Possible Contact Between Gearbox and Engine Oil Pan Causing Leak

Models:
IS5000Z/C31D, 31HP diesel, zero-turn riding mower

Serial Numbers:
1220-1480

Figure 1. Check Gearbox & Oil Pan Clearance

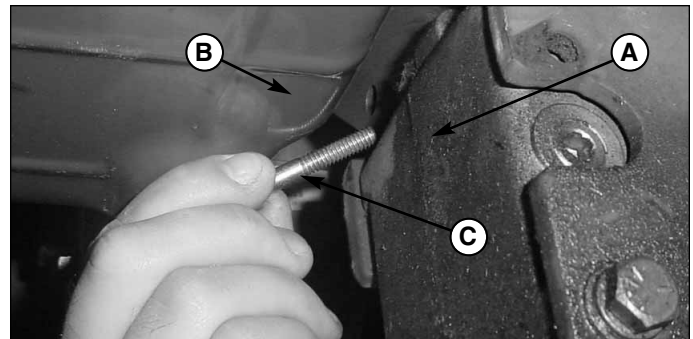
Field reports indicate the deck drive gearbox has the potential to come into contact with the engine oil pan, causing damage to the oil pan that may cause a leak.

1. Park the machine on a flat, level surface and engage the parking brake. Disengage the PTO switch, turn off the engine and remove the key from the ignition.
2. Check the clearance between the gearbox and the engine oil pan (see Figure 1).
3. If you can pass a 1/4" bolt between the gearbox and oil pan, no further action is required. If you **cannot** pass a 1/4" bolt between the gearbox and oil pan, order and install Gearbox Shim Kit (5600028).
